DEVELOPMENT ASSESSMENT REPORT	
<b>Application No.</b>	REV/2020/0033
<b>Address</b>	235 Norton Street LEICHHARDT NSW 2040
<b>Proposal</b>	S8.2 Review of Development Application - review of condition which required deletion of carparking space.
<b>Date of Lodgement</b>	21 December 2020
<b>Applicant</b>	Mr Paul E Ferris
<b>Owner</b>	Mr Paul E Ferris Mrs Ruth A Groves-Ferris
<b>Number of Submissions</b>	Nil
<b>Value of works</b>	\$48,500.00
<b>Reason for determination at Planning Panel</b>	Section 8.2 review request with a recommendation which does not change the prior determination.g
<b>Main Issues</b>	Streetscape, parking location, safety, loss of public parking, non-compliance with relevant Australian Standards.
<b>Recommendation</b>	Uphold previous determination.
<b>Attachment A</b>	Recommended conditions of consent in the event that the DA review application is approved
<b>Attachment B</b>	Plans of proposed development

This report is an assessment of the application submitted to Council for S8.2 Review of Development Application. Specifically, the applicant seeks a review of condition 2, which requires the deletion of the carport and vehicular crossover at 235 Norton Street, Leic

DRIVEWAY SWEEP PATHS FOR B99 VEHICLE ENTRY/EXIT FROM SOUTHERLY DIRECTION  
SCALE:1:100

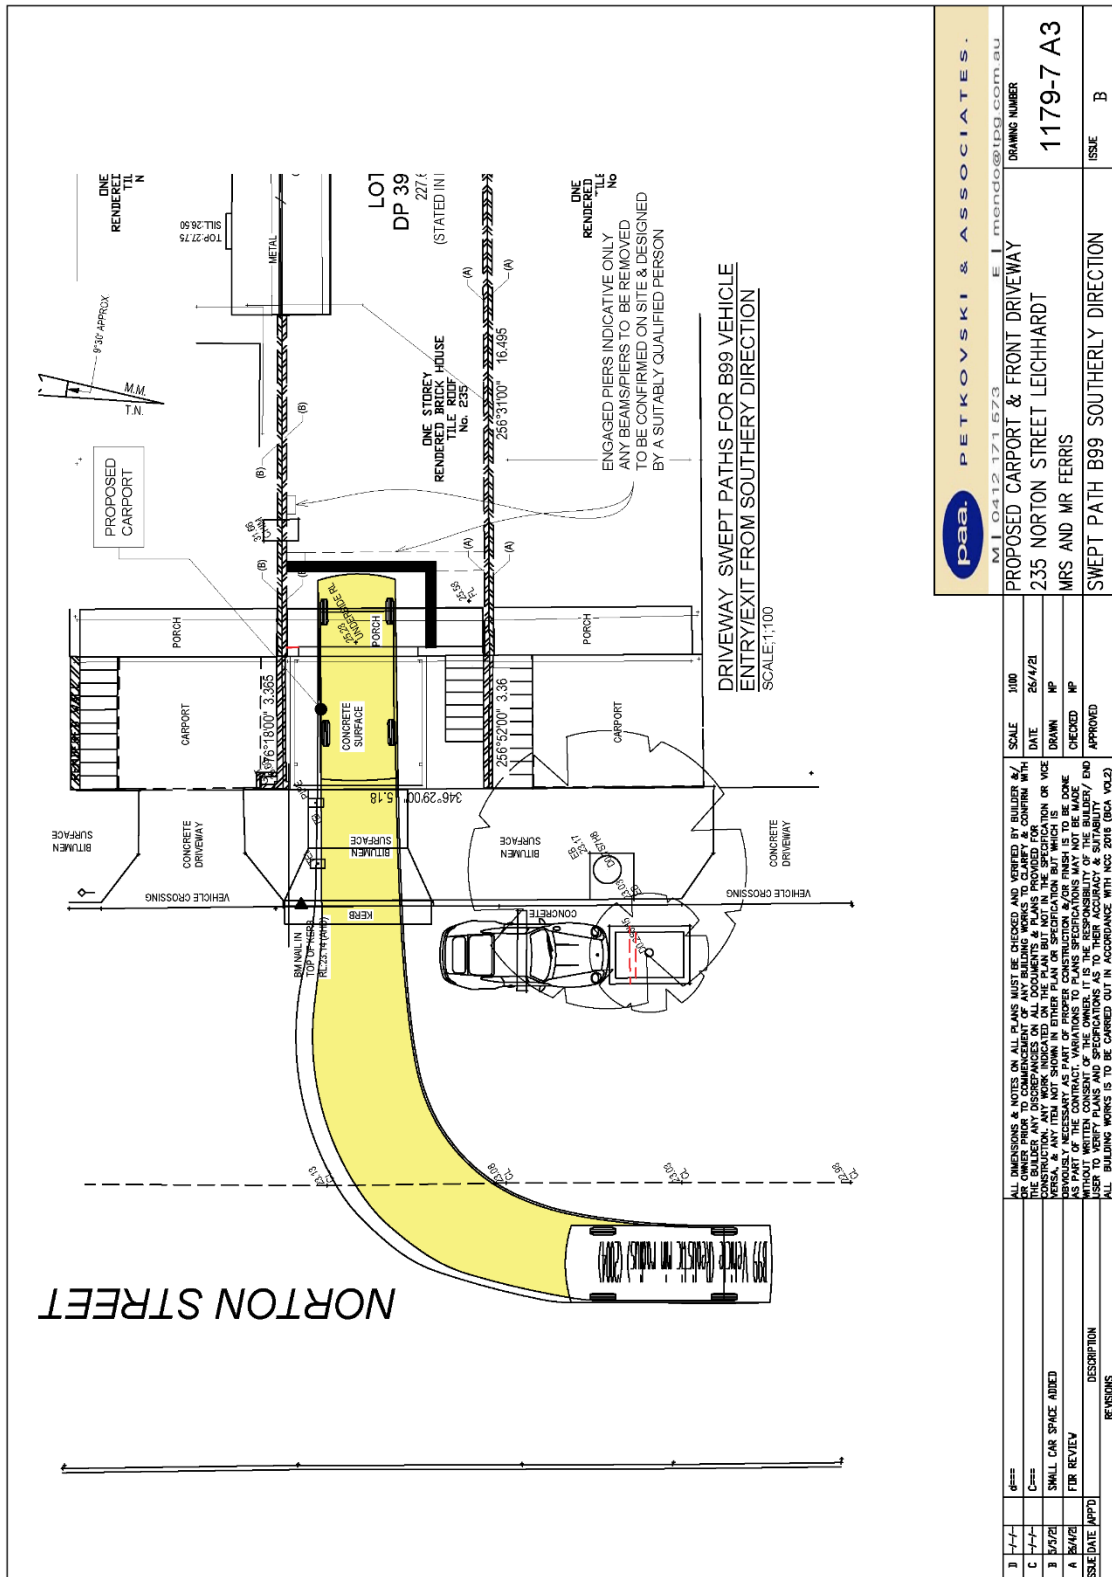
- *Insufficient space is available at the front of the dwelling for a car space. Plans submitted to Council have failed to demonstrate that, the vehicular access and off-street parking facilities comply with Australian Standard AS/NZS2890.1-2004 Parking Facilities – Off-Street Car Parking, Clause C1.11 Parking of the LDCP2013 and the following specific requirements:*

- *A plan of the proposed access and adjacent road, drawn at a 1:200 scale, demonstrating that vehicle manoeuvrability for entry and exit to the parking space complies with swept paths from AS/NZS 2890.1:2004. The plan must include any existing on-street parking spaces.*
